RE: JMC Project 21090
Letchworth Road Residential Development
Letchworth Village Road
Town of Haverstraw, NY

III.C.9 Traffic Transportation and Parking

III.C-7 Water Supply and Sanitary Sewerage

FIGURE: P-1

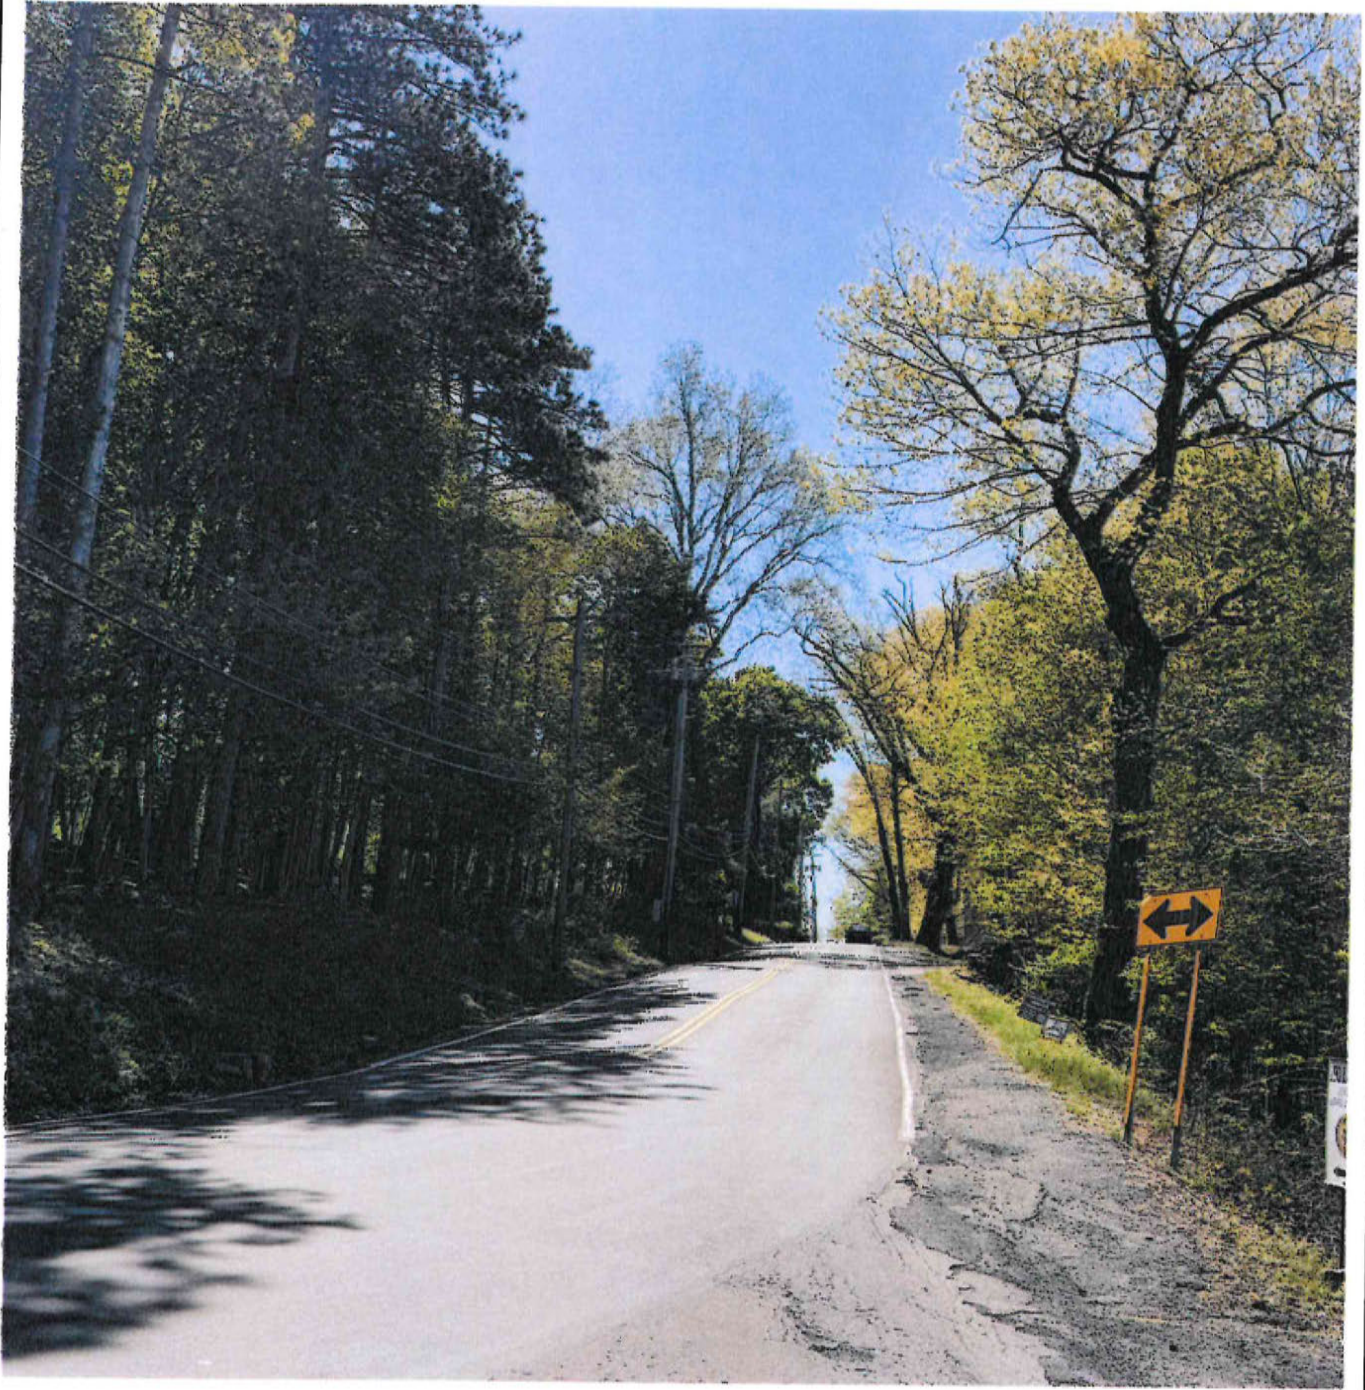
In Response No. 9-11, JMC states that the applicant has recommended the installation of Option B, an all-way stop, at the intersection of Letchworth Village Road and Storrs Road. JMC requests input from the Town of Haverstraw on the desired option for proposed improvements at the intersection.

For the Board's edification, Option A consisted of stop-control on Storrs Road with both Letchworth Village Road approaches operating freely. Both options result in more favorable levels of service in comparison to the existing conditions as well as a more typical intersection configuration in comparison to the existing conditions. As detailed in the DEIS prepared by JMC, dated February 28, 2025, the warrant criteria provided in the Manual on Uniform Traffic Control Devices (MUTCD) for implementing an all-way stop control were either not met or required additional studies, such as the evaluation of the available sight distances for the Storrs Road approach. It is recommended that JMC conduct the sight distance evaluation and the results provided for review prior to the Town opining on its preferred option.

Additionally, photo exhibits (Figures P-1 and P-2) have been prepared to provide the view looking left and right from Storrs Road at a location 14.5 feet from the edge of traveled way along Letchworth Village Road. It should be noted that there is a railing adjacent to the sidewalk in the northwest corner of the intersection. As shown on Figure P-1, the railing does not visually impede the sight distance looking north due to the existing openings within the railing.
